AGREEMENT TO CONSTRUCT  
SUBDIVISION IMPROVEMENTS

PUBLIC INFRASTRUCTURES  
FOR  
TRACT A-1, SUMMIT HILLS SUBDIVISION  
DRB #85-327  
JULY 29, 1985

REF: DRAINAGE REPORT FOR SUMMIT HILLS (J23-D2A) RECEIVED AUGUST 15, 1985

RE: DRAINAGE PLAN FOR SUMMIT HILLS TRACT A-1, 8 LOTS (J23/D2A) RECEIVED  
JUNE 26, 1985.

# STREET CAPACITY VERBENA @ SNOWDACH

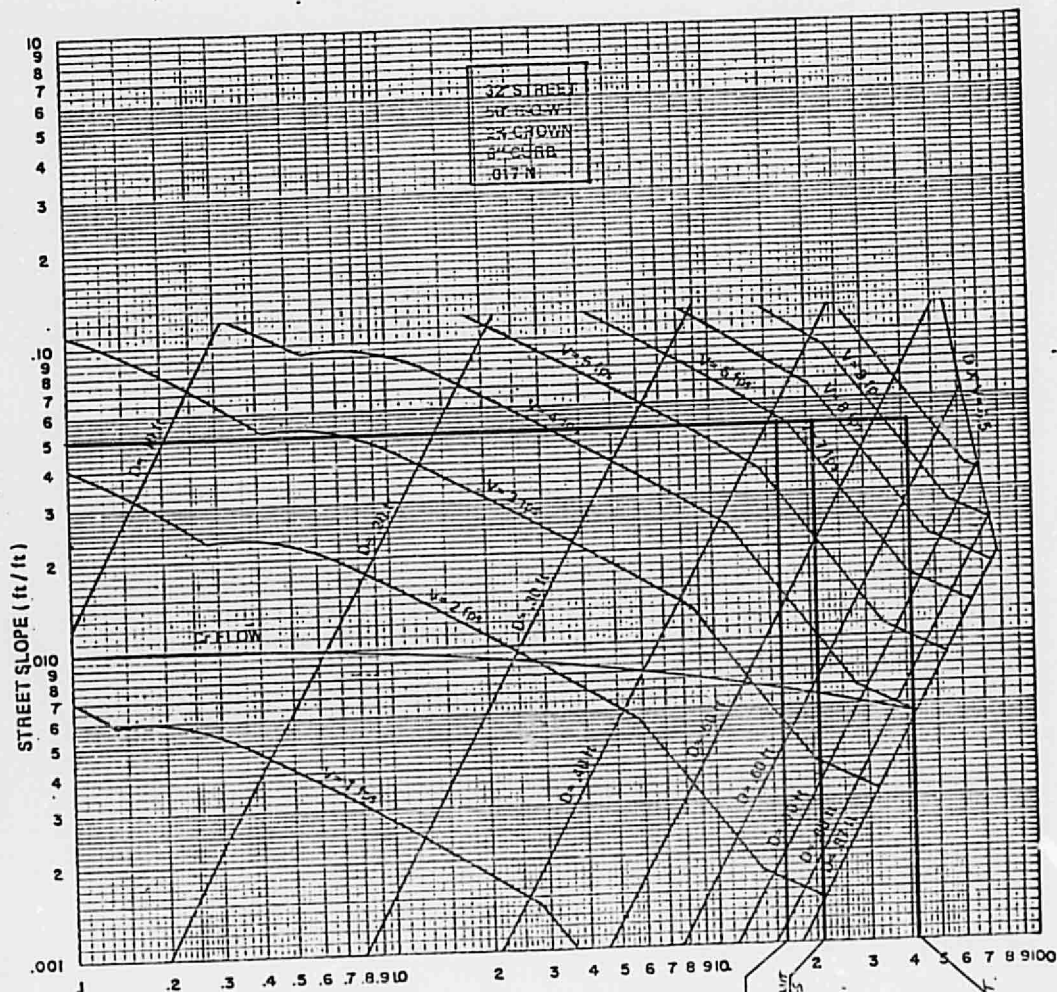
6. Reducing the developed flows below the existing flows does not relieve the engineer of checking downstream capacity. Please check the capacity of flows at Verbena Place and Snowdrop. We have been receiving complaints on this particular corner.

CROWN ON VERBENA = 44.19 - 43.86 = 0.33	
ASSUME FLOWS $\leq d = 0.33$ STAY IN N. FLOW LINE - VERBENA, REMAINDER CROSSES TO S FLOW LINE	
S - VERBENA = $\frac{4}{110} = 0.0364$	
FROM PLATE 22.3 D-1 (for $d = 0.33$ ): $Q = 6.8$ CFS, $V = 4.2$ FPS	
$Q$ CROSSING TO S FLOW LINE = $10.6 - 6.8 = 3.8$ CFS	
NOW ADD OFFSITE FLOWS IN VERBENA.	
DRAINAGE AREA = $\frac{250 \times 690}{2} (120) = 56,000$ SF = 1.3 AC	
SOIL TYPE - TE ( $C = 0.37$ )	
ASSUME $t_2 = 10$ MIN $\Rightarrow I = 5.50$	
$Q = 0.37 (5.50) (1.3) = 2.6$ CFS	
FROM PLATE 22.5 D-1: $V = 3.3$ FPS, $d = 0.26$	
NORTH FLOWLINE = $2.6 + 0.8 = 3.4$ CFS	
ASSUME FLOWS WITH $d = 0.33$ STAY IN N. FLOWLINE - VERBENA, REMAINDER CROSSES TO SOUTH FLOWLINE	
FROM PLATE 22.3 D-1: $Q = 6.8$ CFS, $V = 4.2$ FPS	
$d + \frac{V^4}{2g} = 0.33 + \frac{(4.2)^4}{2(32.2)} = 0.60 < 0.87$ OK	
SOUTH FLOWLINE = $3.8 + (3.4 - 0.8) = 6.4$ CFS	
FROM PLATE 22.3 D-1: $V = 4.1$ FPS, $d = 0.32 < 0.50$ OK
